Revision of Manuscript Number: IEEE-TPWRS-01391-2021, version 1 March 9, 2022

Journal: IEEE Transactions on Power Systems

Author: Abhishek Halder, Kenneth F. Caluya, Pegah Ojaghi, Xinbo Geng

Response to decision:

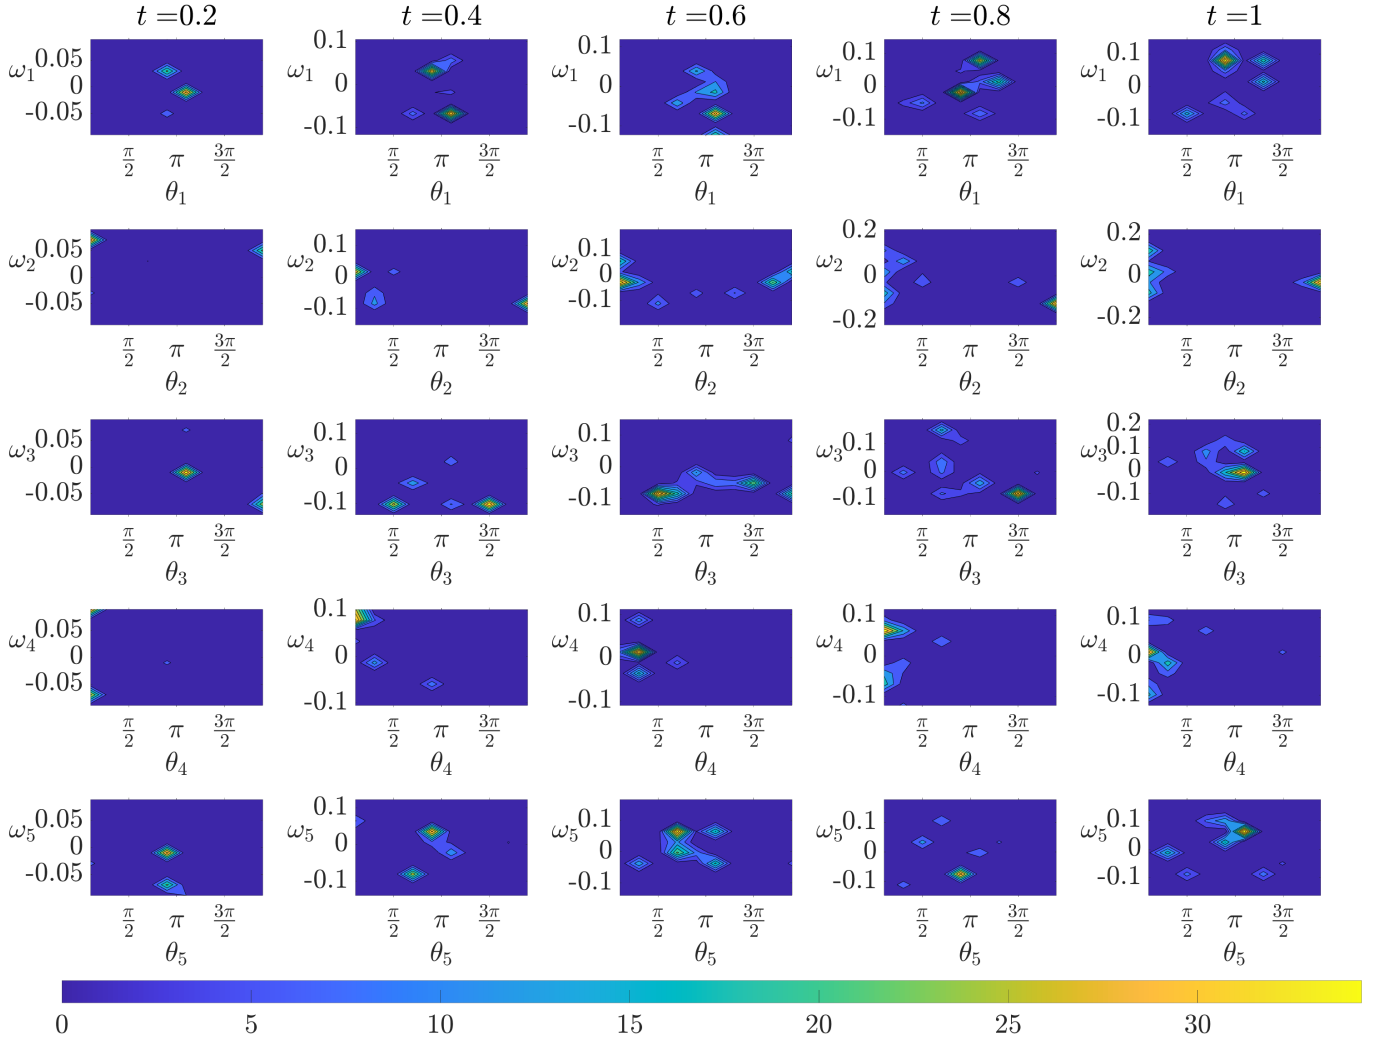
Figures 5 and 6 are unreadable.

Response: Thanks for this comment. In the previous version, the strict 10 page limit enforced small figure sizes. In the revised manuscript, Figures 5 and 6 are made larger. Also, the Fig. 6 in the revised manuscript shows the transient (θ_i, ω_i) bivariate marginals for all the five generators in Case II; the previous version showed the same only for the generator 4 (bus 6). We believe these changes have improved clarity.

Regarding the style of plots, we had considered plotting the bivariate marginals as planar contour plots (as in Fig. 1 in this rebuttal document) but decided against it because of the following two reasons.

First, in our opinion, this kind of plot is scientifically misleading as they hide the fact that these bivariate marginal PDFs are not really supported on the plane, or the subsets thereof, but instead have cylindrical supports. Our message that the proposed method explicitly accounts this manifold geometry in the computation, would be missed had we chosen to make the plots the other way.

Second, the planar contour marginal plots require additional mental efforts from the readers to correctly parse the statistical information conveyed. For instance, consider the fourth column, second row subplot in Fig. 1 in this rebuttal document. It is upon the reader to parse that the two high probability regions on the left and right of that subplot are actually referring to the same angular high probability region around $\theta_2 = 0$ rad, thanks to the periodic boundary condition on the angular variable. We thus prefer to make plots that depict the variables as they are.
